City Planning Commission Meeting Tuesday, November 11, 2014

PRELIMINARY STAFF REPORT

Zoning Docket: 113/14 Date: October 30, 2014

Request: This is a request for a conditional use to permit an elementary school in an RS-2

Tree Protection Plan 200 L100

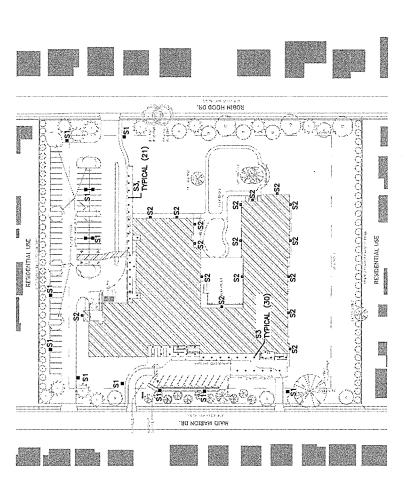
The landscape plan shows a combination of trees and groundcover throughout the site. The proposal includes a tree protection plan for existing trees on the site and it includes instructions on how the trees will be protected during construction. The existing trees include two pine trees adjacent to the sidewalk on Robin Hood Drive, a large willow tree near the property line on Maid Marion Drive, and four unidentified trees within the interior of the site. No tree plantings are shown within the public right-of-way. The applicant proposes to plant additional trees adjacent to the right-of-way on Robin Hood and Maid Marion Drives, along the property lines on the Prentiss Avenue and Pressburg Street sides of the site, and on parking islands within the parking lot on the Pressburg Street side of the site. There are two existing trees within the proposed play area outside of the building footprint. No trees or shrubs are shown within the play area in the courtyard. The landscape plan includes a plant schedule with the genus, species, size, and quantity of proposed plant materials. The landscape plan must be approved by the Department of Parks and Parkways and the plans must be stamped by a licensed Louisiana landscape architect. Therefore, the staff recommends the following standard proviso:

- The developer shall submit an updated landscape plan prepared by a licensed Louisiana landscape architect, subject to final approval by City Planning Commission staff and by the Department of Parks and Parkways indicating the following:
 - a. The genus, species, size, location, quantity, and irrigation of all proposed plant materials within both the common areas and the street rights-of-way within

SHERWOOD FOREST 09.19,2014 BUILDING ELEVATIONS

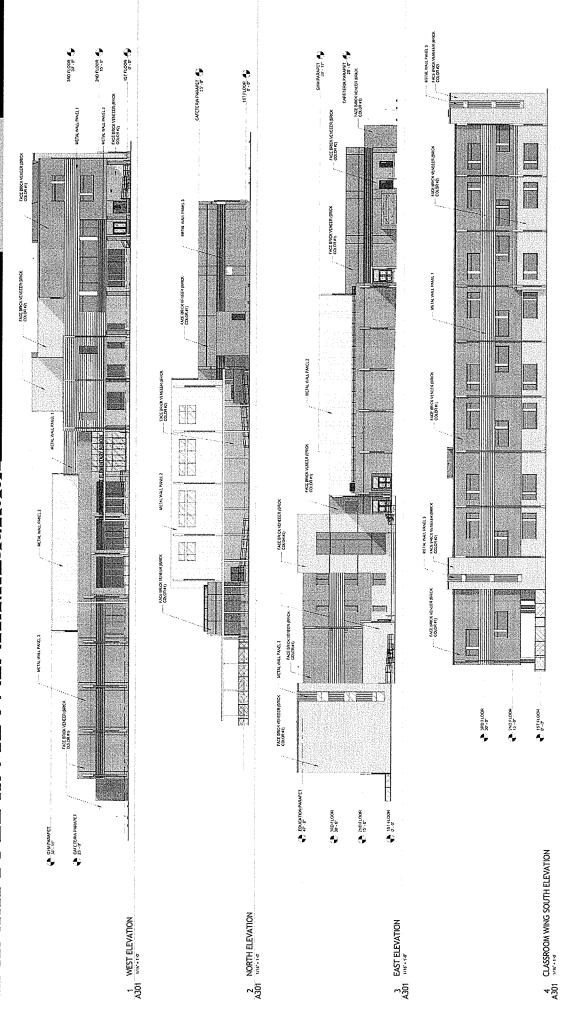
Signs are shown on the elevation drawings for the Maid Marion Drive side of the site. A sign is shown on the canopy in front of the entrance on Maid Marion Drive. A monument sign is proposed in front of the parking area on Maid Marion Drive. More detailed information is needed regarding the dimensions for the proposed signage which must comply with the standards in Article 4.3.6 and Article 12 of the Comprehensive Zoning Ordinance. Staff recommends the following:

• The applicant shall submit revised elevation drawings and signage plans which meet the requirements of Article 4, Section 4.3.6 Permitted Signs and Article 12 General Sign Regulations of the Comprehensive Zoning Ordinance.
